ENGINEERING DEPARTMENT  
TOWN OF WHITBY

**PROJECT/LOCATION**  
**OLDE WINCHESTER**  
**BROOKLIN, ONT**

**DRAWING**  
**SITE GRADING PLAN**

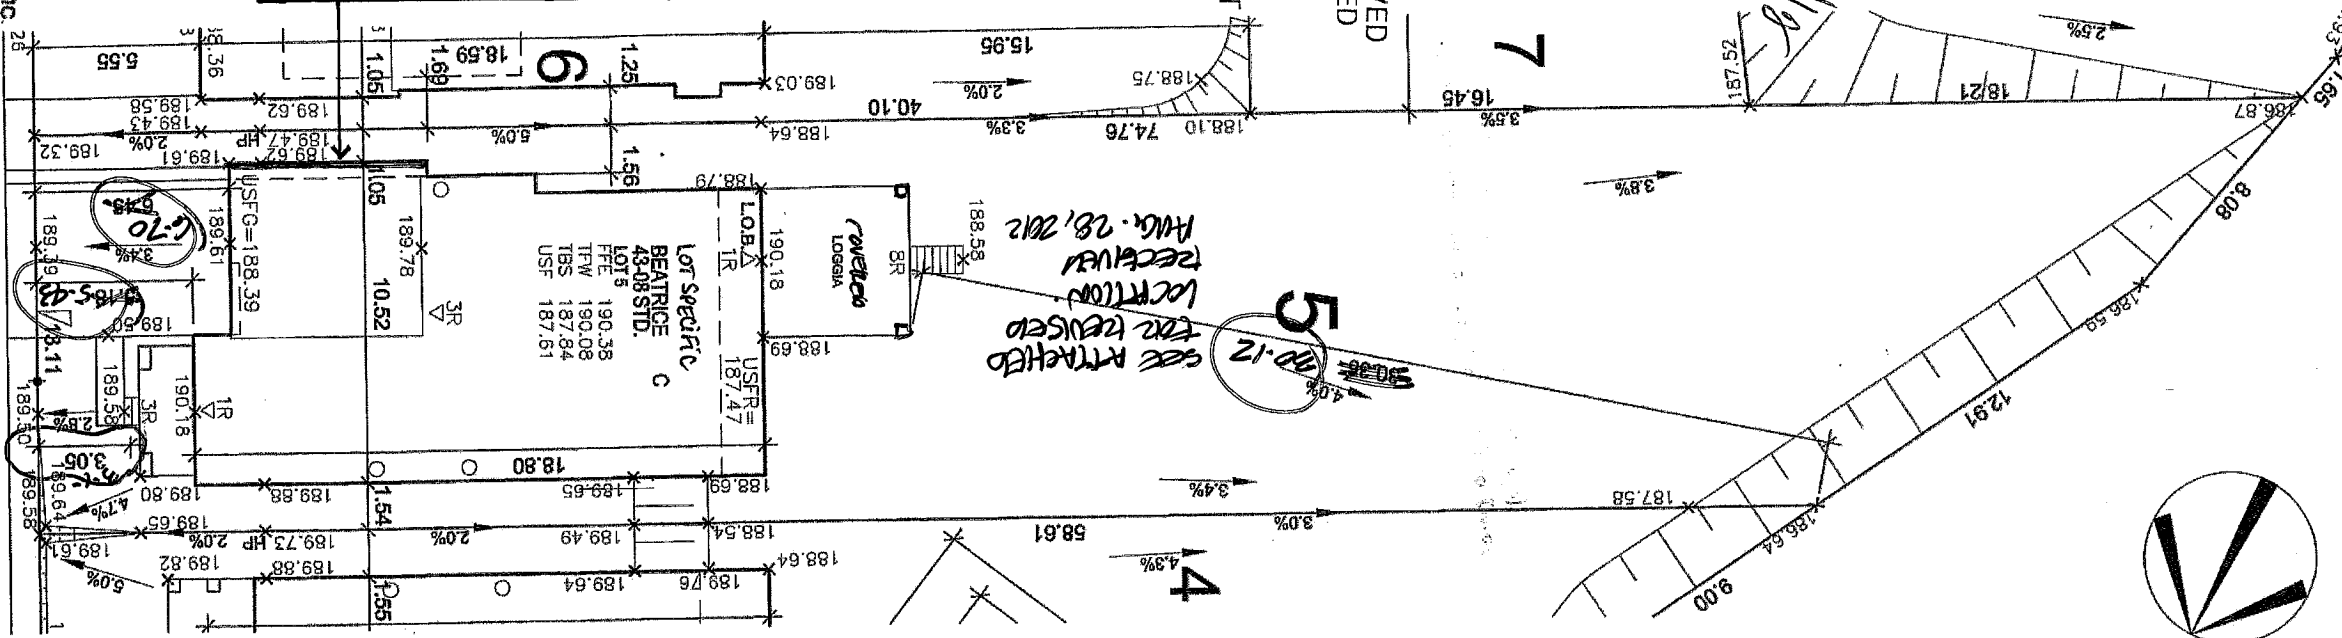
$$\begin{aligned} BH &= 24.2^\circ \\ &= 7.77 + 0.675 \\ &= 8.045 \end{aligned}$$

NOTE:  
PROVIDE MINIMUM 45 MINUTE  
FIRE-RESISTANCE RATING TO  
EXPOSED BUILDING FACE AS  
REQ. BY IBC 7-10.5.5-(2)(b)

REG. PLAN NO.	40M-2416
ZONE	R2B- <del>1/4</del>
LOT NUMBER	5
LOT AREA(m) <sup>2</sup>	888.09 m2
BLDG AREA(m) <sup>2</sup>	220 <del>888.09</del> m2
LOT COVERAGE(%)	24.52% <del>100%</del>
No. OF STOREYS	2
MEAN HEIGHT(m)	<del>8.01</del> 8.01
PEAK HEIGHT(m)	NA
DECK LINE(m)	NA
